City of Portland, Maine – Building or Use Permit Application 389 Congress Street, 04101, Tel: (207) 874-8703, FAX: 874-8716

BUILDING PERMIT REPORT

REASON FOR PERMIT: 8x10' deck 6x6 slider

LAND USE - ZONING REPORT

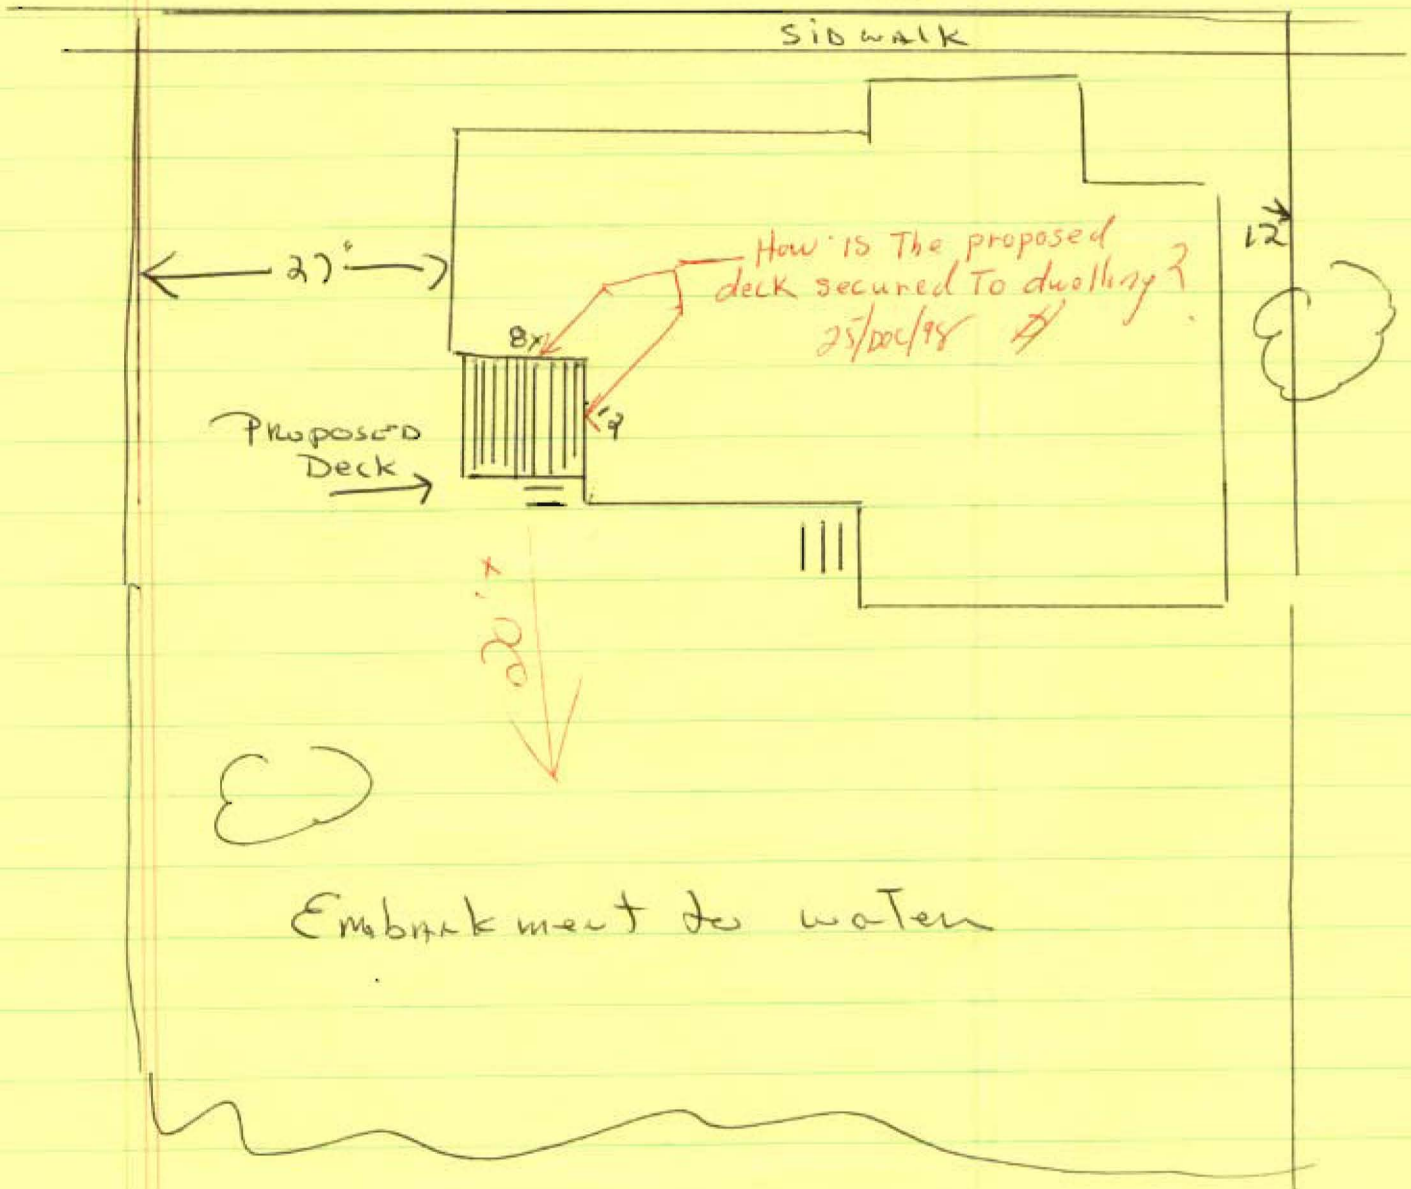
within however I-B Zone states No setback from HWM required under Shoreland Zoning (14-449(a.ii))

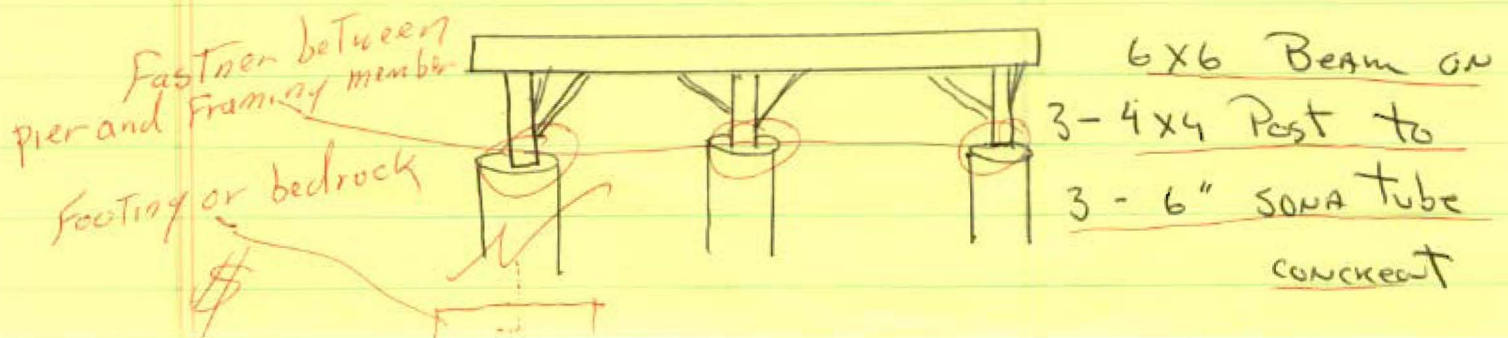
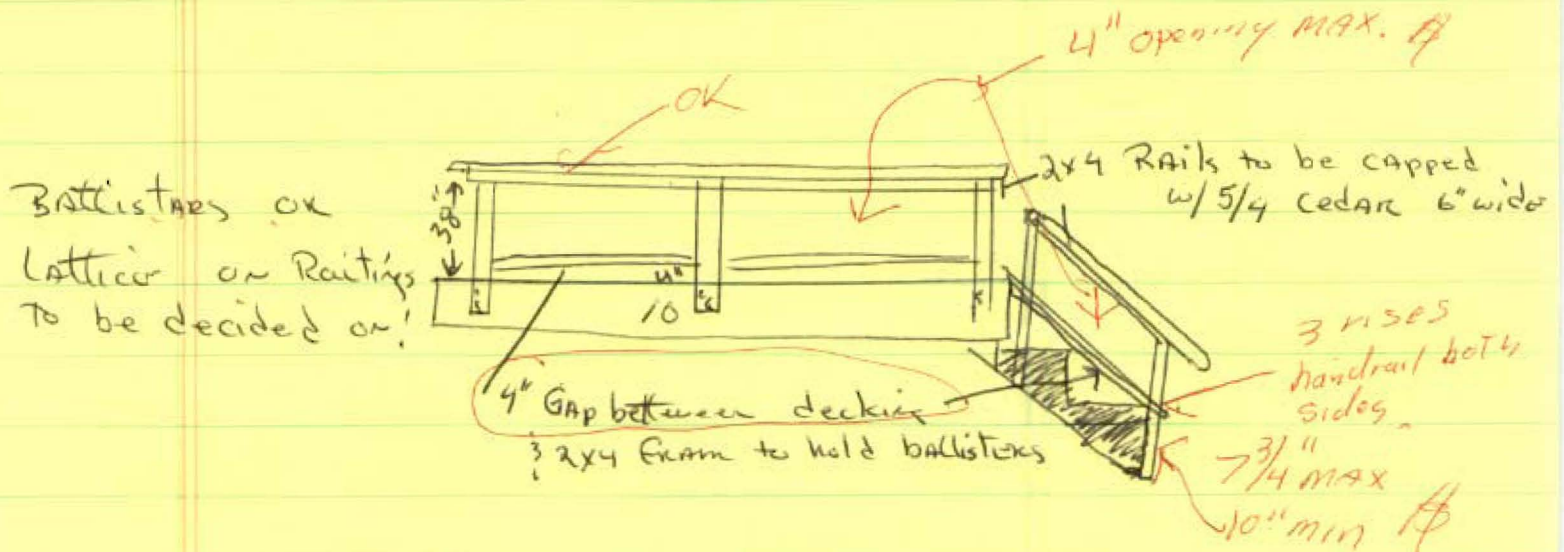
- X32. The proposed deck must be secured to the dwelling in an approved manner
33. _____

6 foot sliden to Replace 6ft window
use existing header for new door
